## QUALITY ASSURANCE -- NON-CONFORMANCE REPORT

**Report No:** NCR-000469

**Reference Description:** Unapproved freehand thermal cutting on North Tower, Lift 1

**Job Name:** SAS Superstructure  
**Document No:** 05.03.06-000432

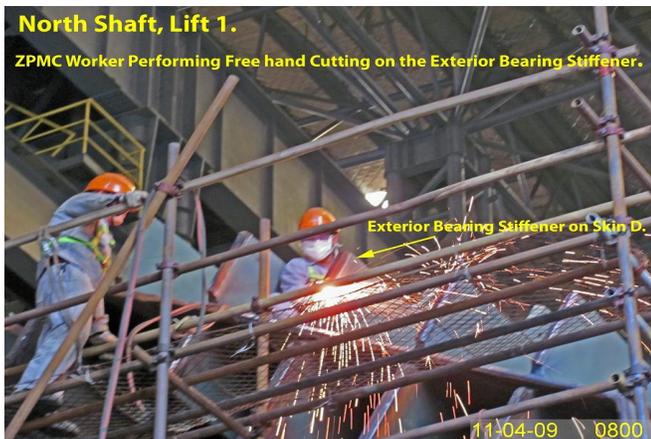
During Visual Testing (VT) of North Tower, Lift 1, exterior bearing stiffeners, QA observed 'freehand thermal cutting' being carried out by ZPMC personnel without Engineer approval.

Propose a resolution for the identified non-conformance, documenting that the affected plate edges have been brought in compliance with the contract requirements.

In addition, to the material/workmanship non-conformance, propose a resolution for the identified non-conformance that addresses the failure of Quality Control to identify the deficiency.

Provide documentation of the steps/actions taken by the Quality Control Manager with regard to both Production and Quality Control to prevent future occurrences.

**Report No:** NCR-000463

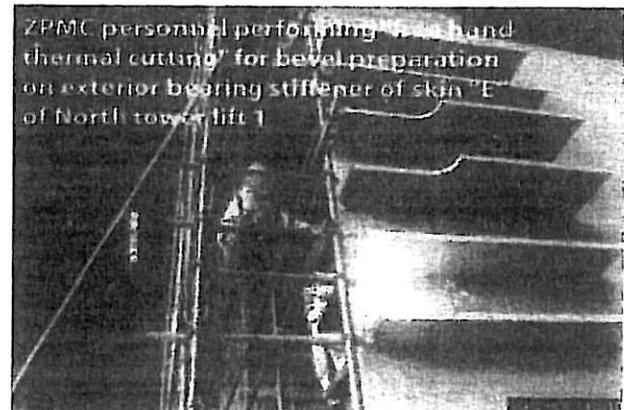
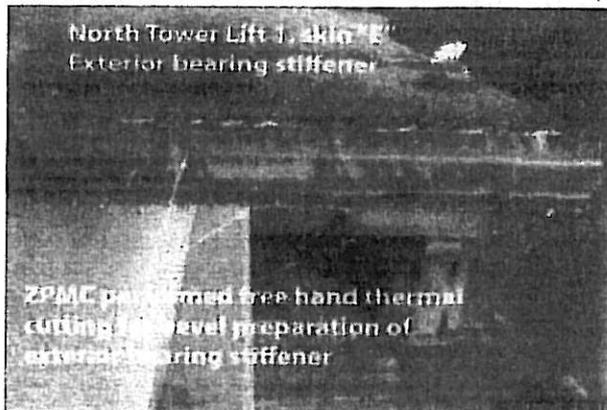
During Visual Testing (VT) of North Tower, Lift 1, Skin E exterior bearing stiffeners, QA observed 'free hand thermal cutting' for bevel preparation being carried out by ZPMC personnel without approval by the Engineer.

Propose a resolution for this systematic non-conformance, documenting that the affected plate edges have been brought in compliance with the contract requirements.

In addition, to the material/workmanship non-conformance, propose a resolution for this systematic non-conformance that addresses the failure of Quality Control to identify the deficiency. NPR ZPMC-391 and NPR ZPMC-412 addressed the same type of non-conformance, ABFJV stated in part, "ZPMC understands and acknowledges that free hand thermal cutting is not permitting without prior Engineer approval and in the future ZPMC CWIs monitor thermal cutting activities closer to ensure that it is in compliance". Please also address the apparent failure of the internal communication within ZPMC that caused this now systematic failure. In the event of another repeated incident of this type, address what steps/ actions will be taken by ABFJV.

**Report No:** NCR-000469

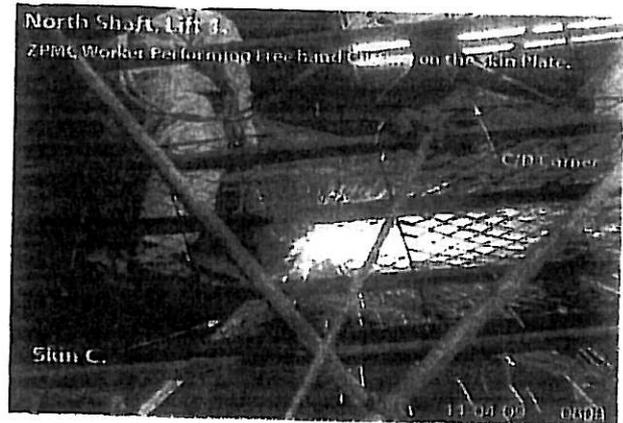
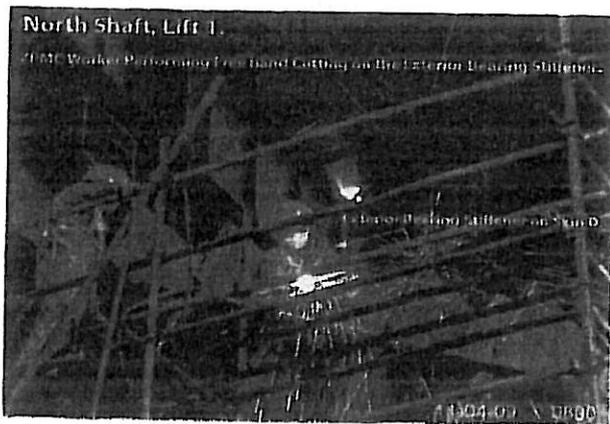
During Visual Testing (VT) of North Tower, Lift 1, exterior bearing stiffeners, QA observed 'freehand thermal cutting' being carried out by ZPMC personnel without Engineer approval.

Propose a resolution for the identified non-conformance, documenting that the affected plate edges have been brought in compliance with the contract requirements.

In addition, to the material/workmanship non-conformance, propose a resolution for the identified non-conformance that addresses the failure of Quality Control to identify the deficiency.

Provide documentation of the steps/actions taken by the Quality Control Manager with regard to both Production and Quality Control to prevent future occurrences.

**Report No:** NCR-000438

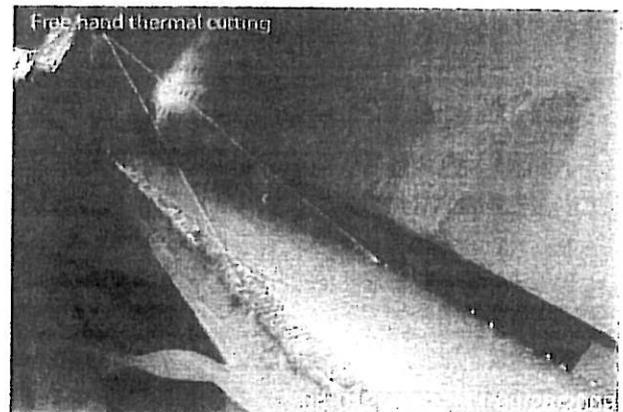
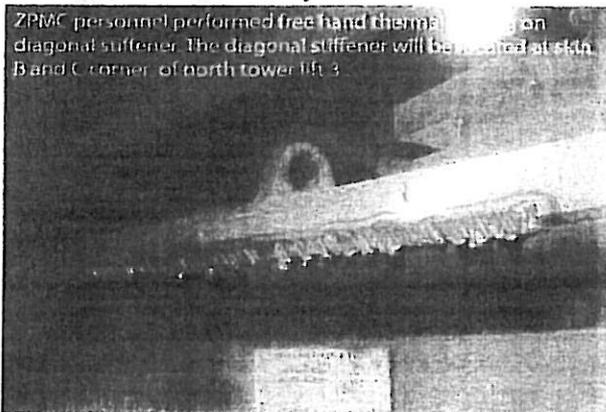
QA observed ZPMC personnel perform free hand thermal cutting on North Tower, Lift 3, BC Diagonal Stiffener, between the 85m and 89m Diaphragms. The length of the cut was approximately 850mm.

Propose a resolution for the identified non-conformance, documenting that the affected plate edges have been brought in compliance with the contract requirements.

In addition, to the material/workmanship non-conformance, propose a resolution for the identified non-conformance that addresses the failure of Quality Control to identify the deficiency.

Provide documentation of the steps/actions taken by the Quality Control Manager with regard to both Production and Quality Control to prevent future occurrences.

Report No: NCR-000417

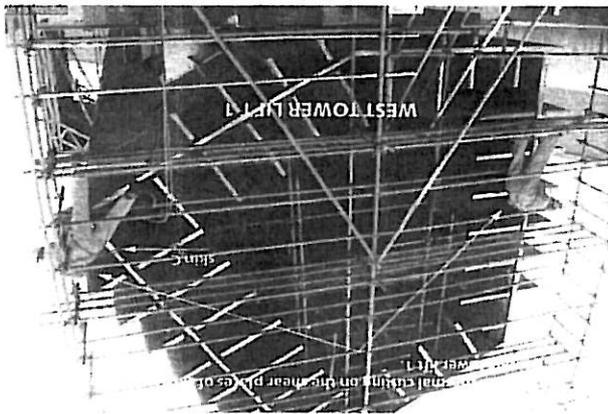
During in-process Visual Testing (VT) of West Tower, Lift 1, base-end bevel preparation, QA observed 'freehand thermal cutting' being carried out by ZPMC personnel. Access to the areas being cut were not restricted due to cross sectional geometry and or position in so far as mechanical guides could not be used.

Propose a resolution for the identified non-conformance, documenting that the affected plate edges have been brought in compliance with the contract requirements.

In addition, to the material/workmanship non-conformance, propose a resolution for the identified non-conformance that addresses the failure of Quality Control to indentify the deficiency.

Provide documentation of the steps/actions taken by the Quality Control Manager with regard to both Production and Quality Control to prevent future occurrences.
